Ardmore Park Quarry – Modification 3

Response regarding  
Groundwater Issues

**SUBJECT: RESPONSE TO DEPARTMENT OF INDUSTRY COMMENTS ON EA  
ARDMORE PARK QUARRY (PA 07\_0155 MOD 3)  
LOT 24 in DP1001312  
5152 OALLEN FORD ROAD BUNGONIA NSW 2580**

**Hydrogeological Assessment**  
**Lot 24 DP1001312 - 'Ardmore Park'**  
 Schematic Cross Section

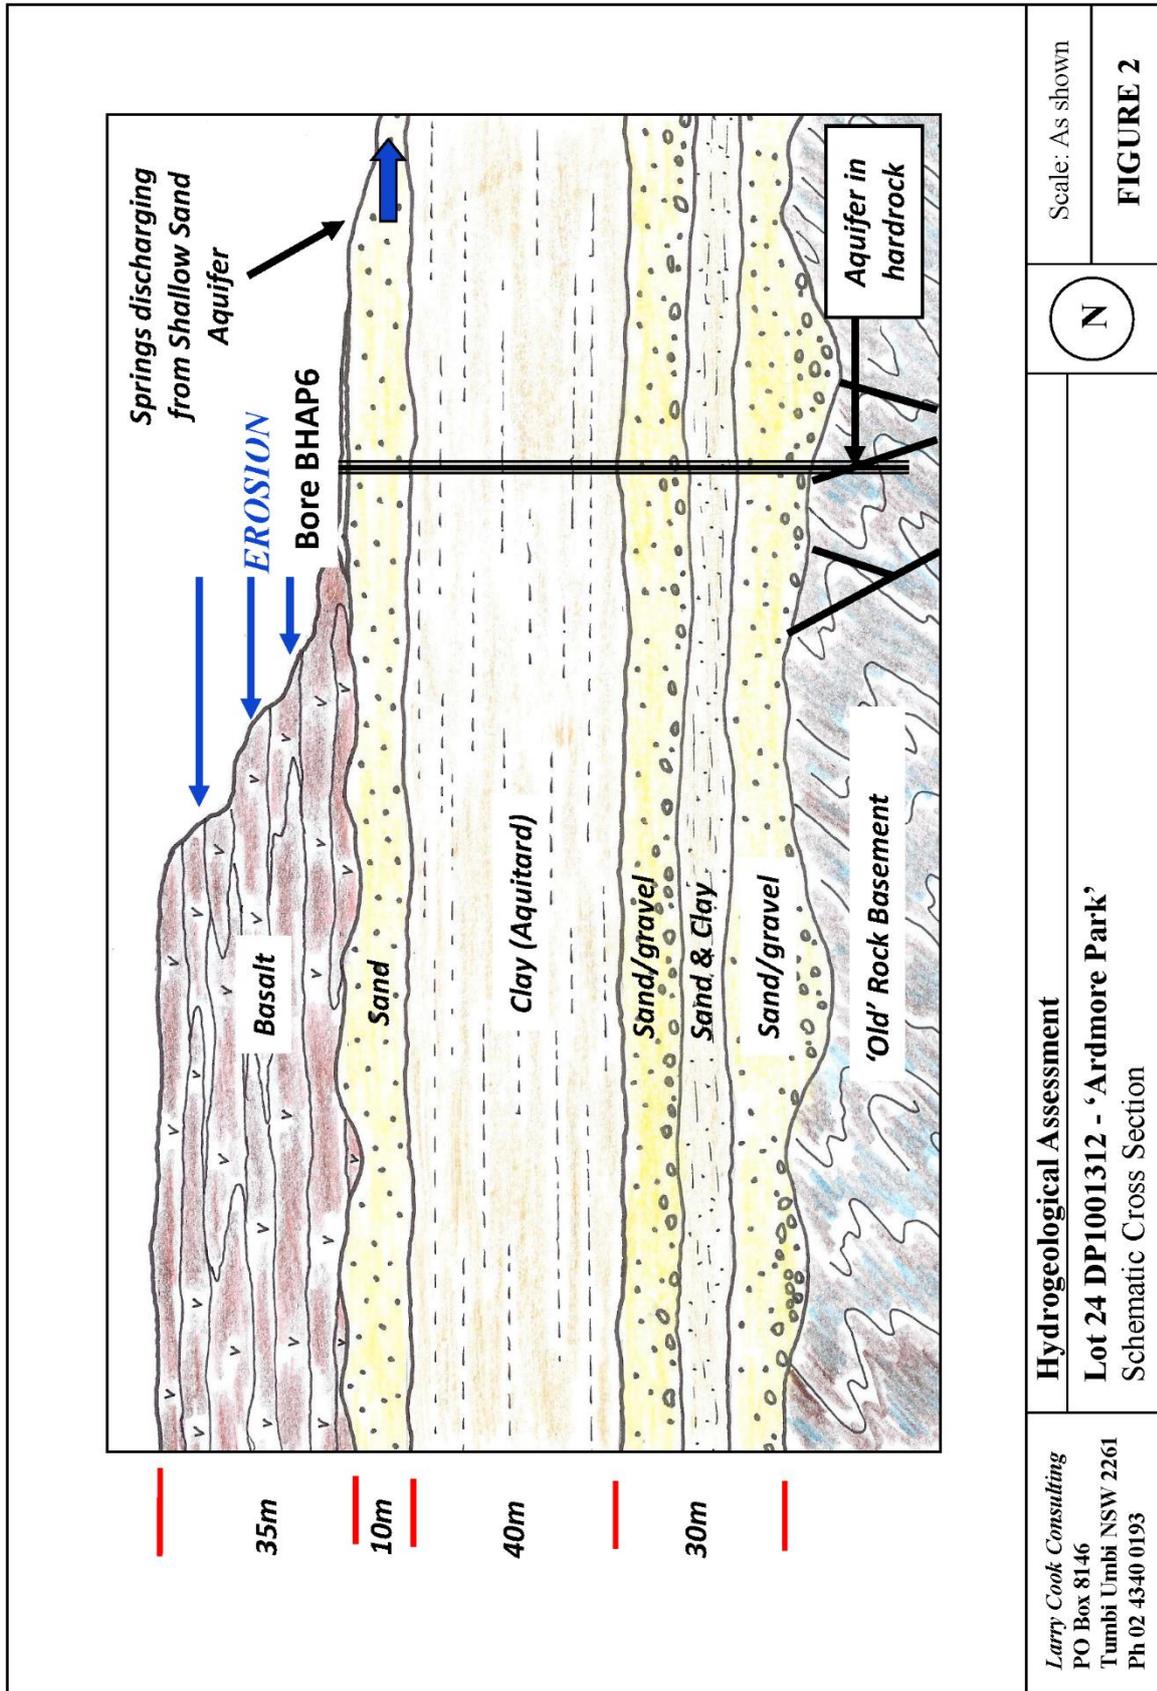
*To assist in understanding the site and predicted impact, cross sections of the conceptual hydrogeology model and plots of contoured groundwater level for each separate aquifer presented in the Hydrogeology Assessment should be provided.*

A schematic cross section showing the principal geological elements described above is presented in **Figure 2** and Conceptual Cross Section A-B-C presented in **Figure 3**. The location of the cross section is shown in **Figure 1**.
